| APPLICATION NO. | FILING DATE | FIRST NAMED INVENTOR | ATTORNEY DOCKET NO. | CONFIRMATION NO. |
|-----------------|-------------|----------------------|---------------------|------------------|
| 10/718,195 | 11/20/2003 | David C. Racenet | 1879 CON III | 9798 |

| Office Action Summary | Application No. 10/718,195 | Applicant(s) RACENET ET AL. | |

DETAILED ACTION

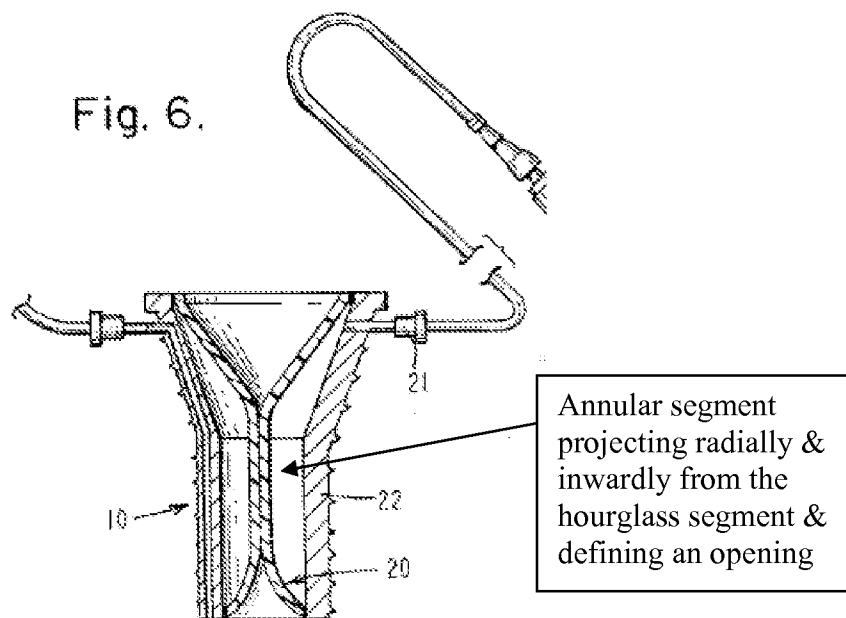
Figure 6 illustrates the sealing member (20) having a general hourglass shaped segment. Figures 5 & 6 illustrates the sealing member (20) having an annular segment and the annular segment defining an opening. See illustration below.

The Mollenauer et al device, however, discloses its seal member (20) is of elastomeric/elastic material instead of fabric material, as required by claims 5 & 33.

Therefore, it would have been obvious to one skilled in the art to modify the Mollenauer et al sealing member (20) such that it would include a layer of fabric, as taught by Stablein, for purposes of providing not only flexibility during insertion of the endoscope (34) but also greater resistance, thus, to form a tighter fluidic seal in relation about the endoscope (34).
